Disability Access Report

**Medowie Mixed-Use  
Development**

795 Medowie Road  
MEDOWIE NSW

For: Mavid Group  
Ref: LP\_18177

Figure 1 | Accessible Path of Travel

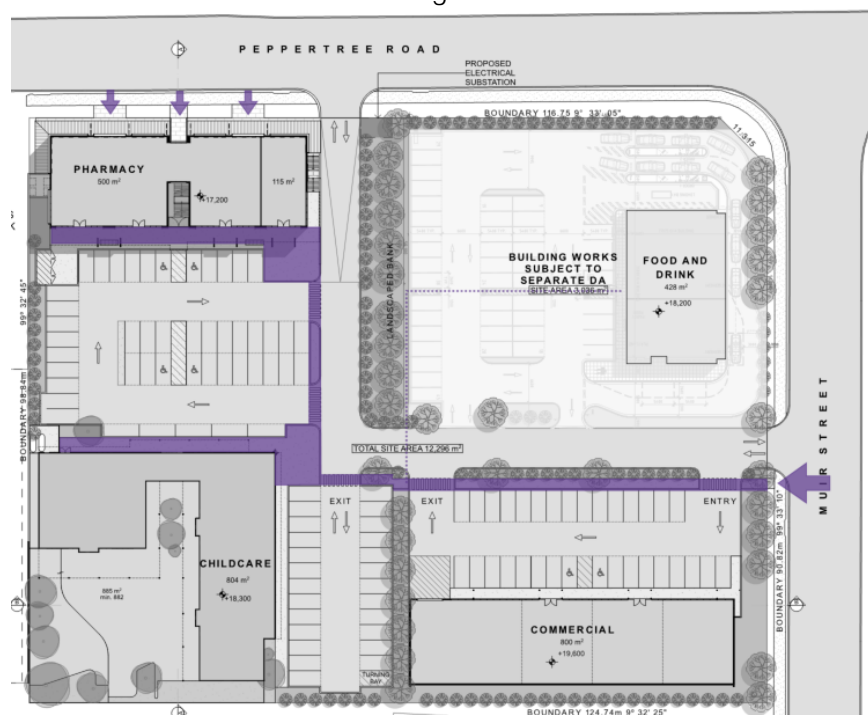
An accessible path of travel is available from the street footpath along Muir Road to all building entrances.

An accessible path of travel is available from the street footpath along Peppertree Road to the commercial tenancies at that level.

An accessible path of travel is available from the accessible carparking areas to all building entrances.

An accessible path of travel is available between the four buildings on the site.

Figure 2 | Location of Food and Drink Outlet

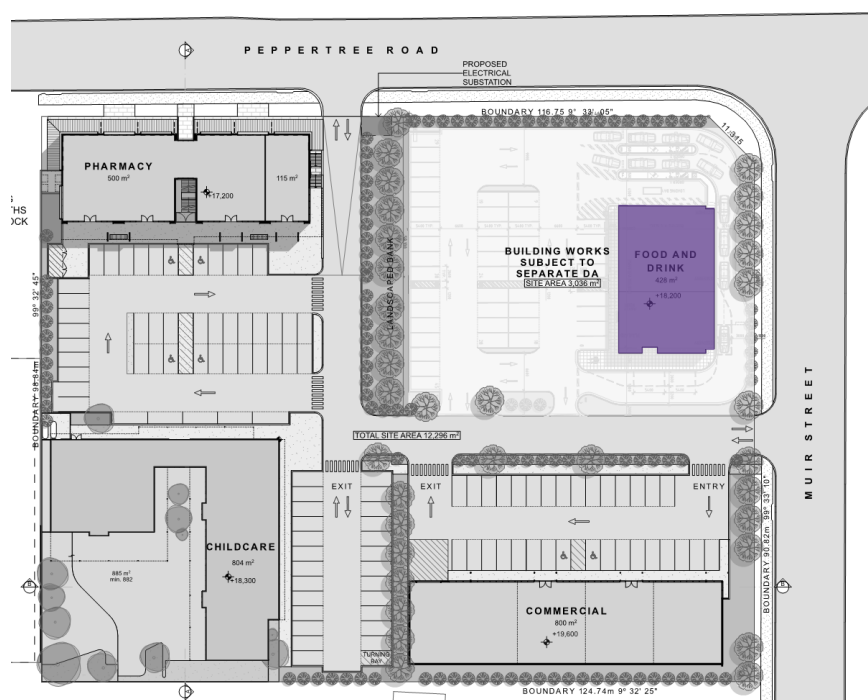
The proposed site works will provide access to the food and drink outlet. Pedestrian areas extend to the area and accessible carparking is provided.

Figure 5 | Location of Commercial Building

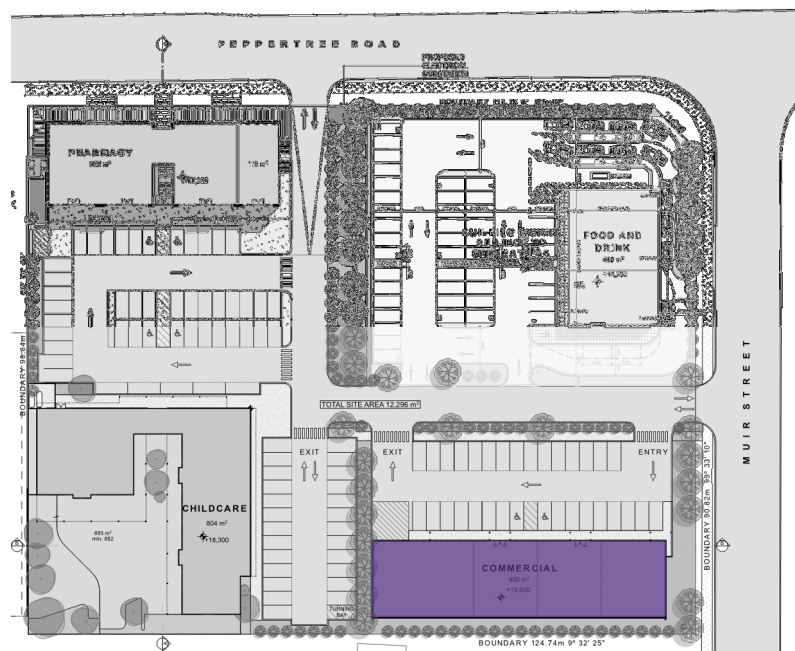
Double swinging doorways provide entry to the Commercial Building.

- a. Entrance to comply with AS1428.1(2009), Clause 13 as part of the accessible path of travel.

- b. Door are to have a minimum clear opening width of 850mm to comply AS1428.1(2009), Clause 13.2 as part of the accessible path of travel.
- c. Door threshold to be level to provide seamless entry as part of the accessible path of travel. Maximum allowable construction tolerance is 3mm for compliance with AS1428.1(2009), 5mm where beveled edges are provided between surfaces – refer to Figure 6.

- d. Door to have hardware within the accessible height range of 900-1100mm above the finished floor level (AS1428.1(2009), Clause 13.5)
- e. For glass doors, provide decals to assist persons with a vision impairment. Decals to be solid and have a minimum 30% luminance contrast to the background colour and be not less than 75mm high located within the height range of 900-1100mm above the finished floor level. Decals are to be solid. AS1428.1, Clause 6.6.

- f. For a best practice approach to access, and to assist people with a vision impairment locate the entrance, consider providing features with a minimum 30% luminance contrast to the background surface such as an entry mat or awning.
